INTRODUCTION

OUTLINE OF NEW FEATURES

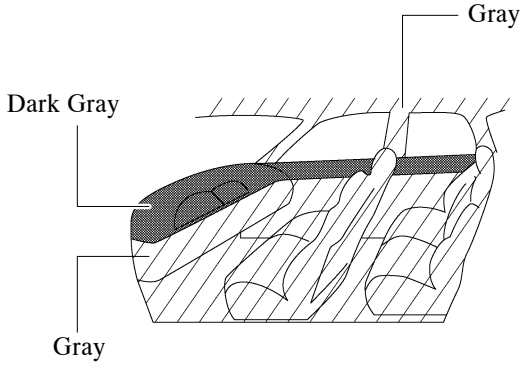
- The interior colors have been changed as follows:

▶ Table of Seat Fabric ◀

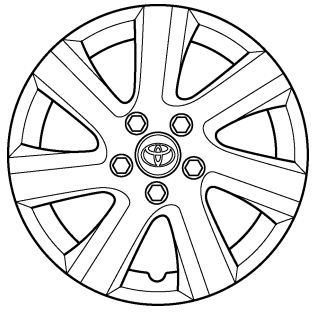
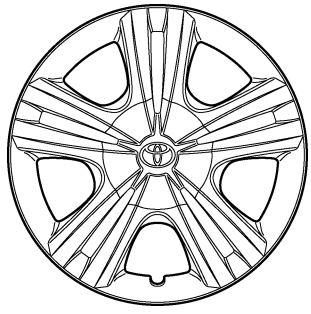
Item	Changed	Camry	Aurion
Instrument Panel and Trim Woodgrain	The instrument panel and trim woodgrain have been changed from the high gloss (22BN61) to the semi gloss (22BN75).	-	×
Seatback Pocket	The seatback pocket has been changed to hard board type for enhanced appearance.	×	-
Seat Fabric	The seat fabric design has been changed. For details, refer to the table on the next page.	×	×
Ashtray	**Models for Australia:** • The ashtray has been discontinued.	×	-
	Models for G.C.C. Countries: • The ashtray has been changed from the pullout type to a removable cup that can be installed to the cup holders.

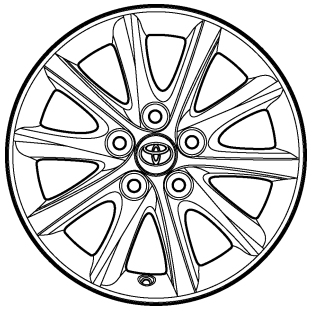
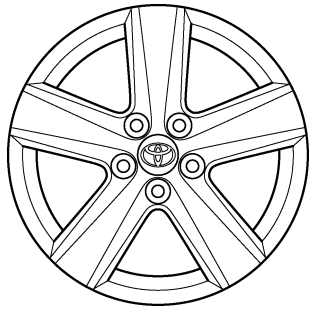
- The wheel cap, 16-inch and 17-inch wheels have been changed for Camry.

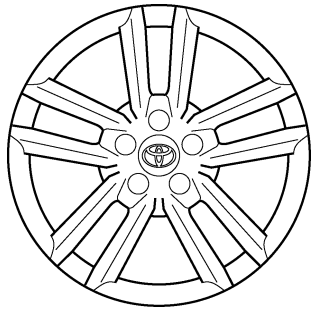
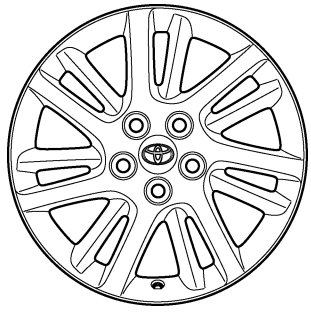
- The 16-inch and 17-inch wheels have been changed for Aurion.
